**TECHNICAL ENFORCEMENT SUPPORT
AT HAZARDOUS WASTE SITES**

CDM Federal Programs Corporation

A remedial investigation and the beginnings of a feasibility study (FS) have been conducted in three phases at the Universal Oil Products (UOP) site in East Rutherford, New Jersey. Volatile and semi-volatile compounds are widespread in high concentrations at the site. Polychlorinated biphenyls and inorganics are found in several areas of the site.

Water Table Contours

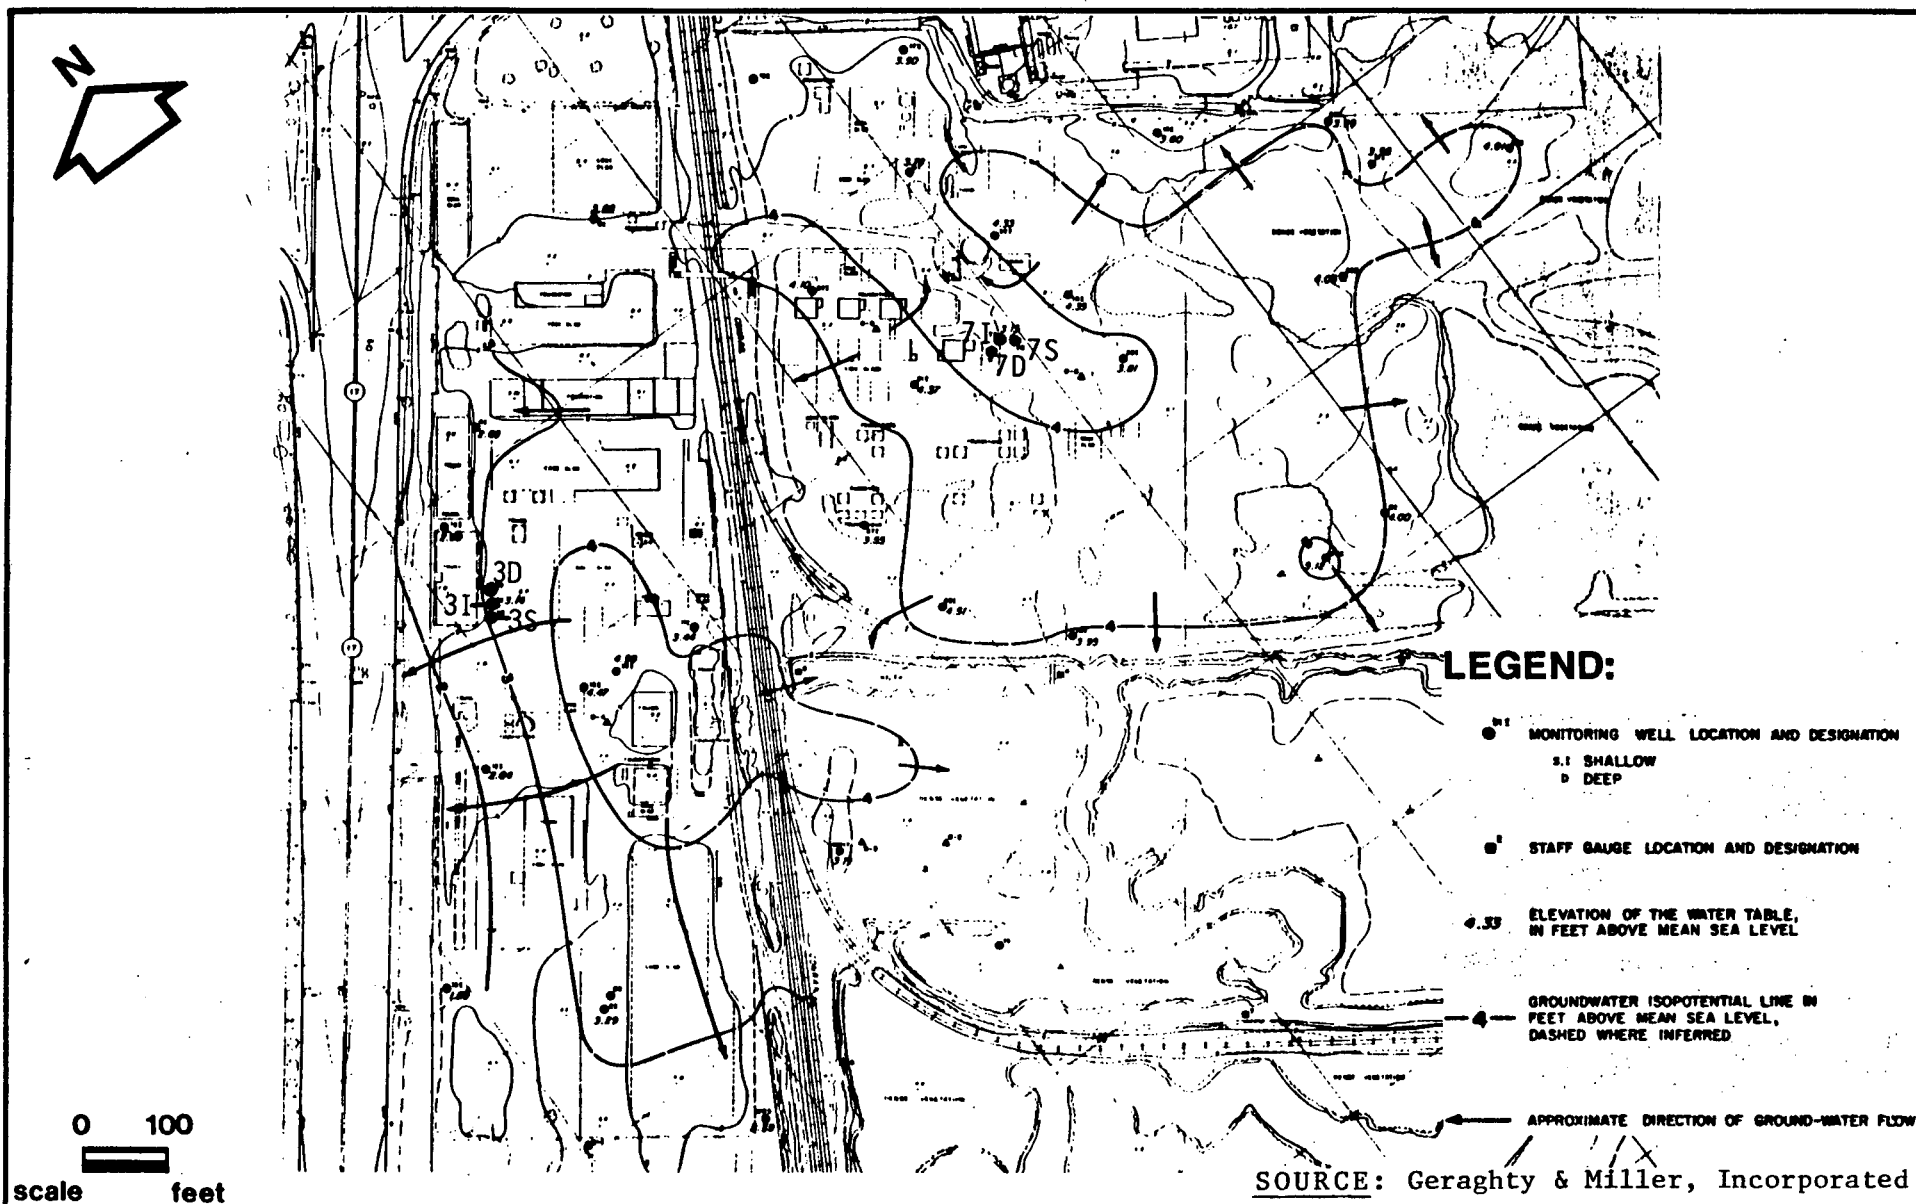
A net upward flow throughout the site has not been established, although it probably exists at the two locations where deep wells were installed (3D and 7D, Figure 5). The existence of low levels of contamination in both deep wells may refute the theory that the purported upward gradient is protecting the lower aquifer.

Figure 6
Volatile Organic Compounds In Ground Water
1985 - 1986

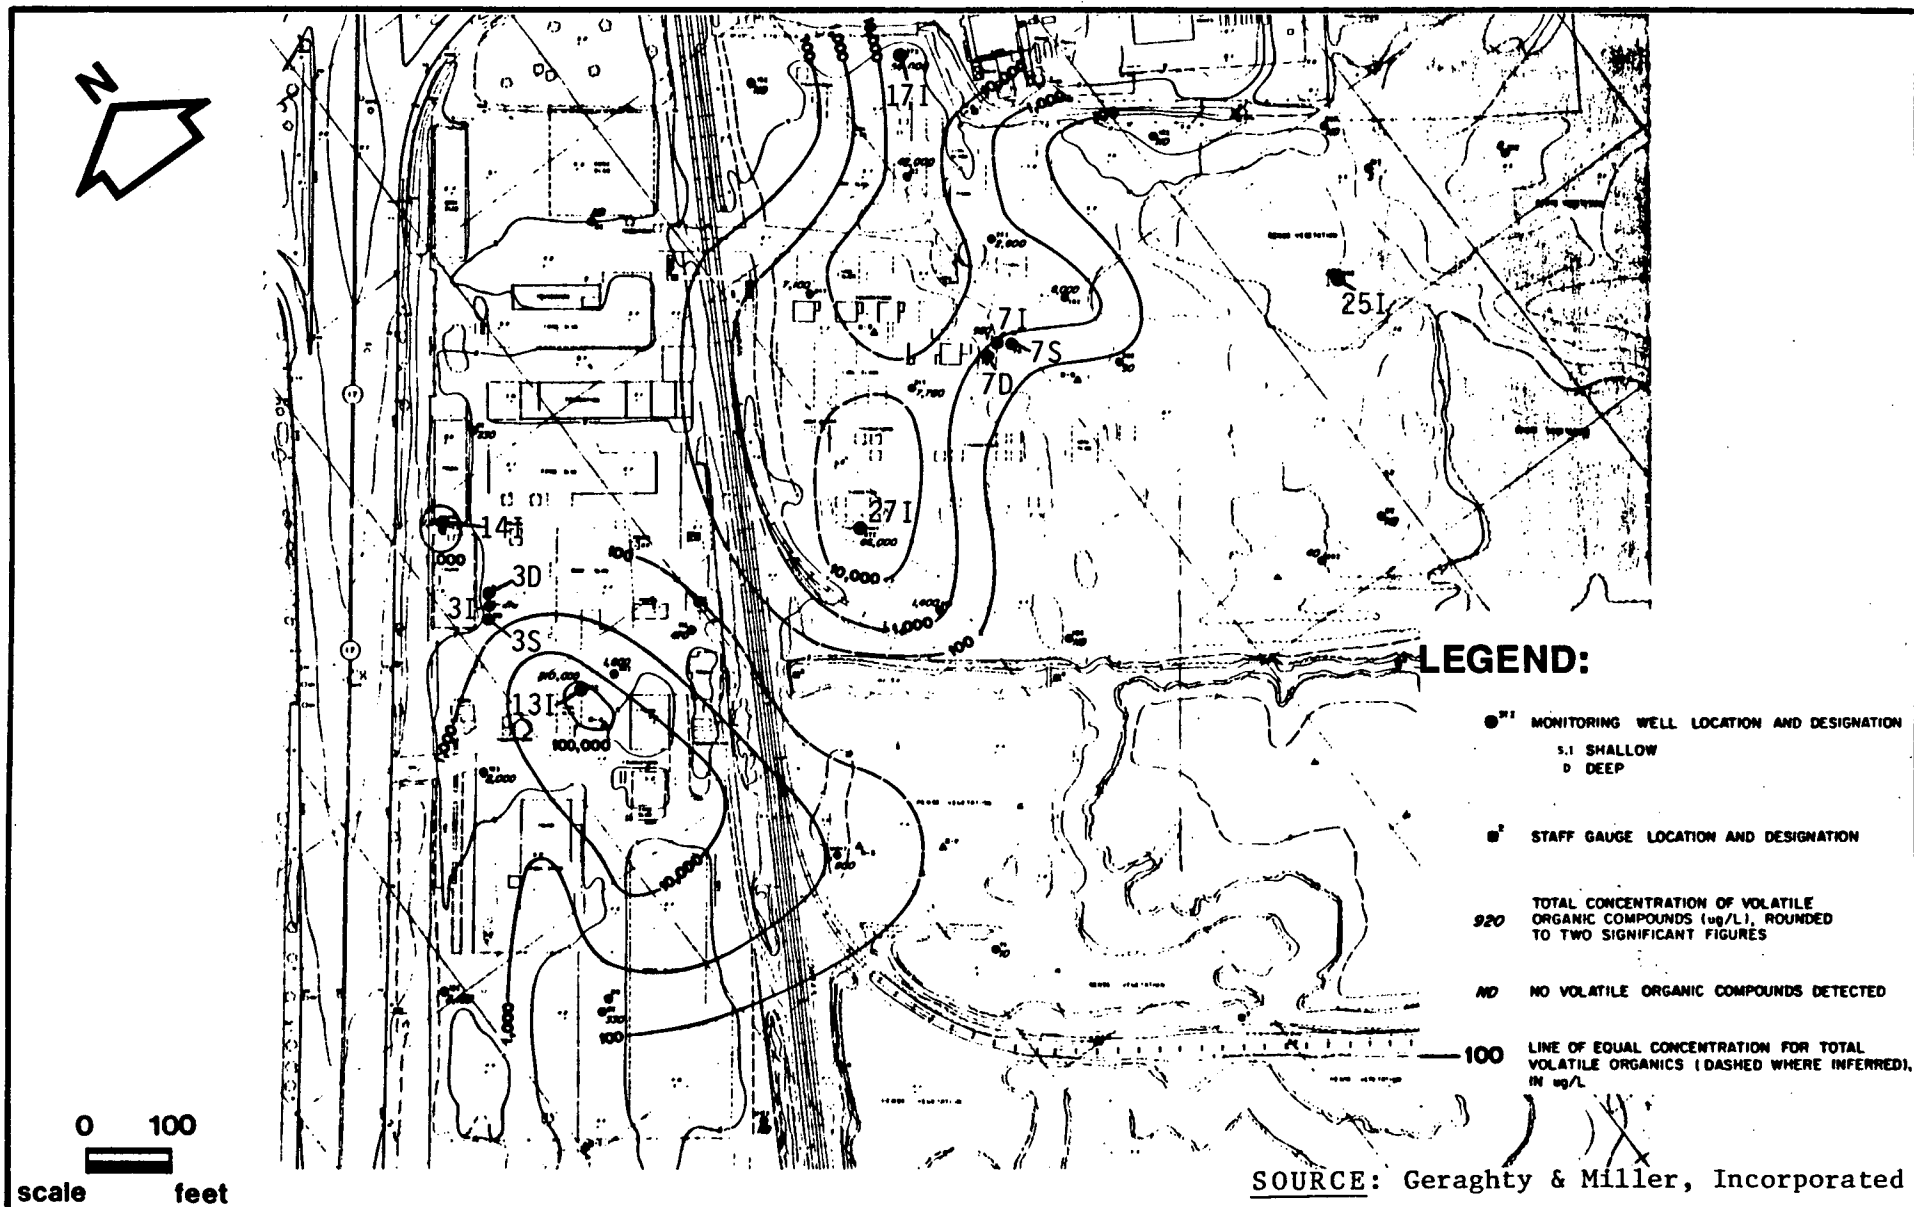
The highest VOC and BNA concentrations have been detected in the shallow aquifer at the northern and northeastern boundaries (Area 2 and 1A), but sampling was limited to the site boundary during the investigation. Additional ground water, soil, and surface water sampling beyond site boundaries is necessary to determine the extent of contamination. The shallow aquifer flow pattern supports the need to sample off-site to the north, northeast, and west of the site boundary (Figure 6).

G&M stated that VOCs are notably absent in Area 5. However, the fact that the VOC's are much higher in Areas 1, 1A, and 2 than in Area 5 does not negate their presence in Area 5. The ground water VOC contour map (Figure 6) is misleading. The data suggests that the 1,000 ppb and 100 ppb isopleths in Area 2 may be drawn to the north rather than to the west, as G&M has done. If drawn to the north, then the need to sample off-site is further exemplified. A 100 ppb isopleth could be drawn in the eastern portion of Area 5, around Well 25I. Furthermore, for clarity, if a sample was not taken from a well, this should, in the future be symbolized on the map (e.g. NS for "not sampled"). Finally, it is difficult to place contamination in the Lagoons relative to the rest of the site because they are not located in any of the RI figures.

Figure 9
Base/Neutral And Acid Extractable
Organic Compounds In Soils
1983 - 1986
UOP Site
East Rutherford, New Jersey

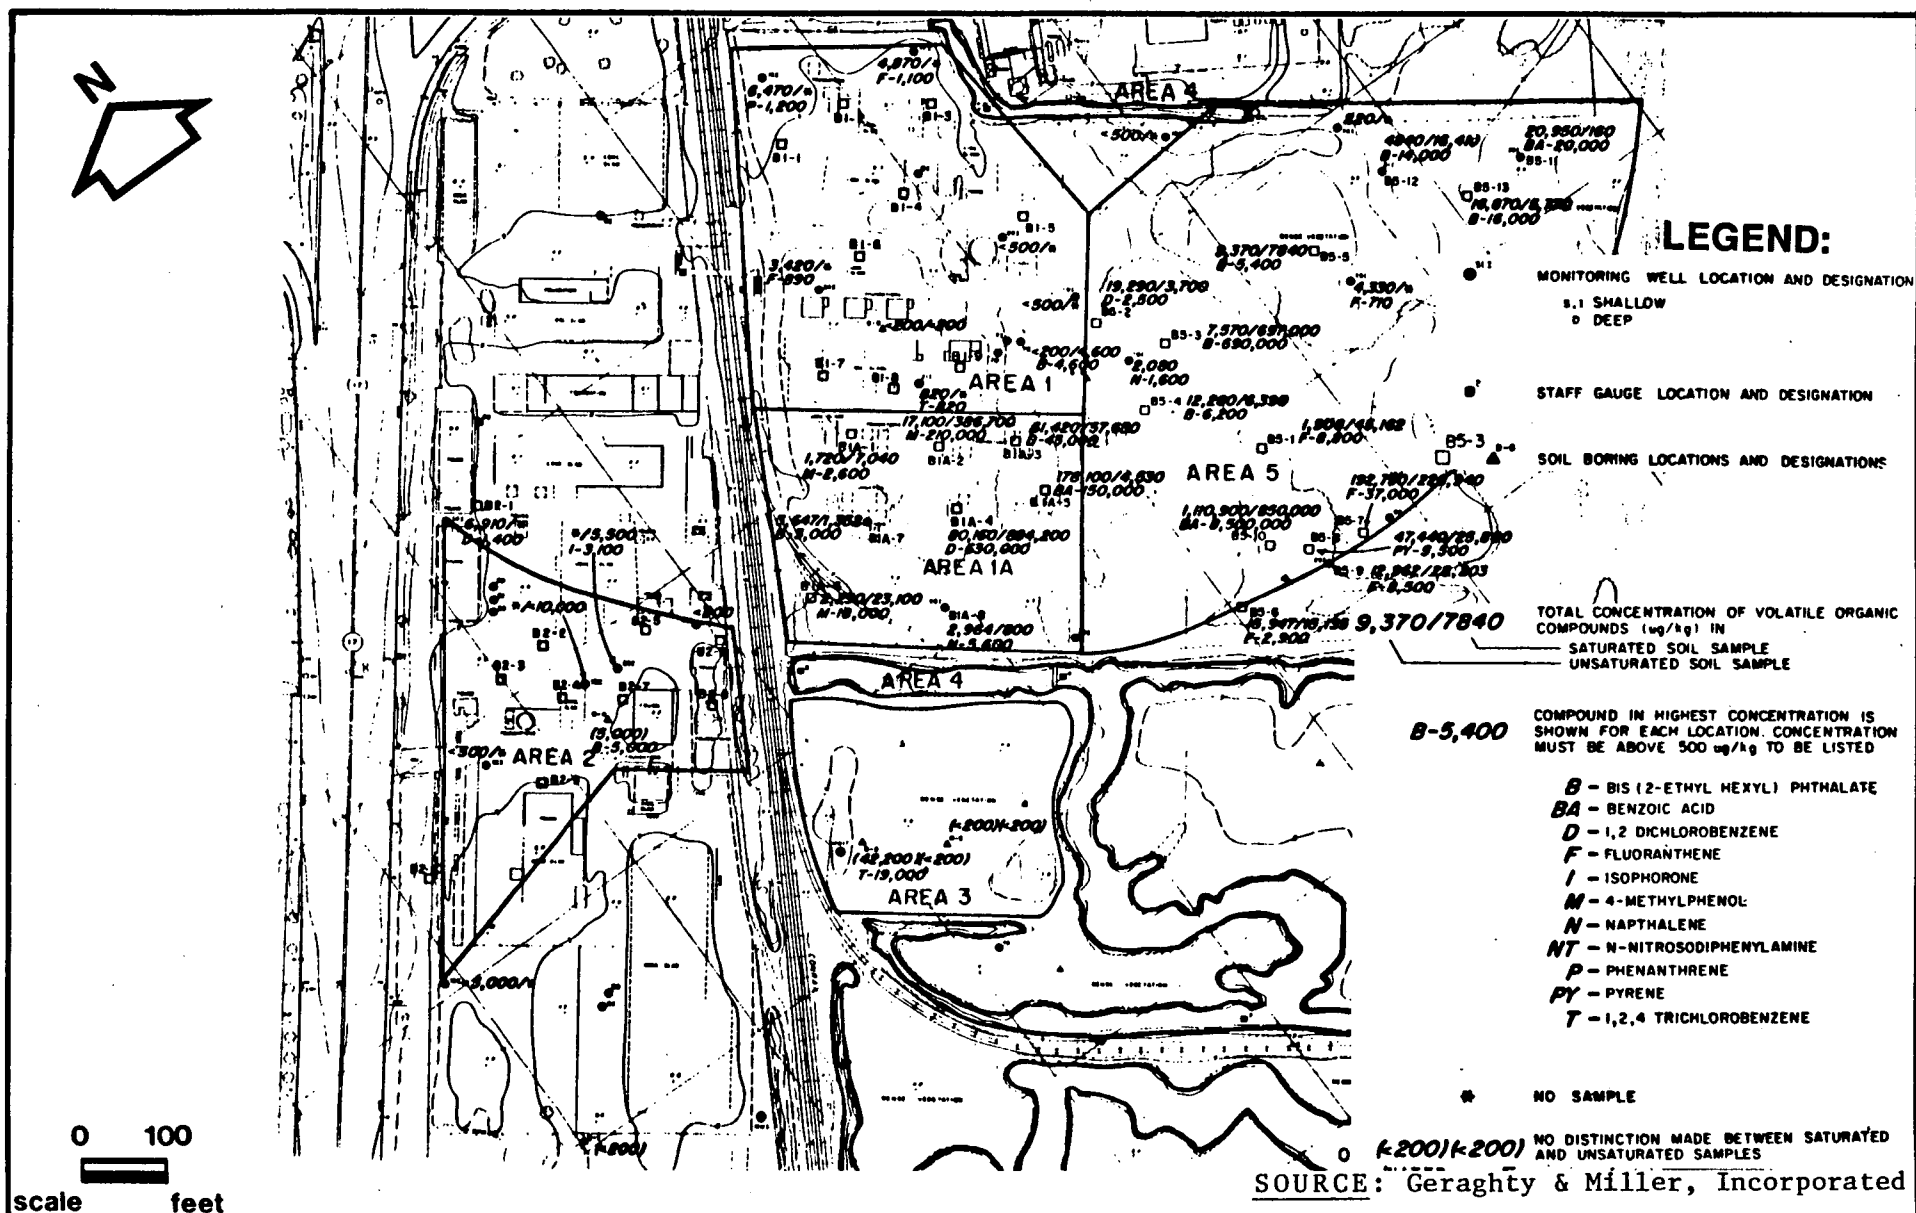
BNAs are present in the upper aquifer at up to 21,000 ppb (Well 13I) and seem to be located around six areas (see Figure 9). BNAs were also detected in low levels (<50 ppb) in both of the deep Wells. BNAs have been detected in parts per million at the site boundary and extend northeast and north from the site for an undetermined distance.
